# Service Bulletin

Bulletin No.: 13-06-01-002A

**Subject:** Conversion of Engine RPO LZG or LZ8 with Active Fuel Management to Non AFM Lifters

**Models:** 2007 Chevrolet Impala VIN Code R (RPO LZ8)  
2008 Chevrolet Impala VIN Code 3 (RPO LZG)  
Equipped with 3.9L Engine

3346615

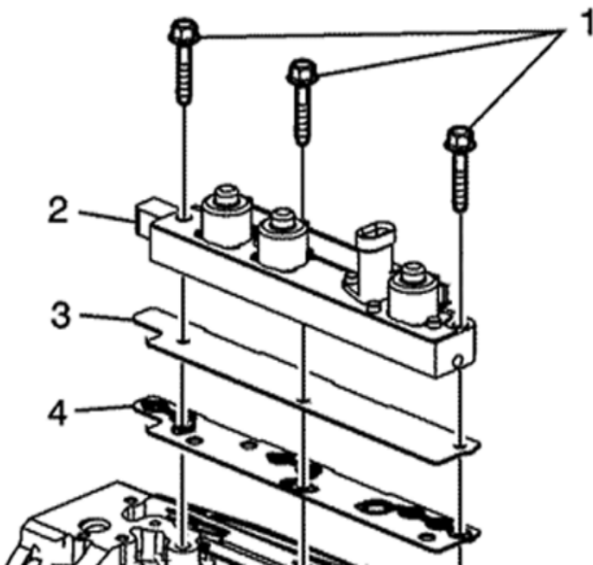
4. Install the new camshaft. Refer to Camshaft Installation in SI.
5. Install the lifters into the engine. Refer to Valve Lifter Installation in SI. Install the 6 non-AFM lifters and lifter guide removed during disassembly into the same lifter bores they were removed from. Install the 6 NEW lifters and lifter guide included in the conversion kit into the AFM lifter bores.

**Important:** Discard the valve lifter guide retainer (2) and bolts (1). They are not used during assembly.
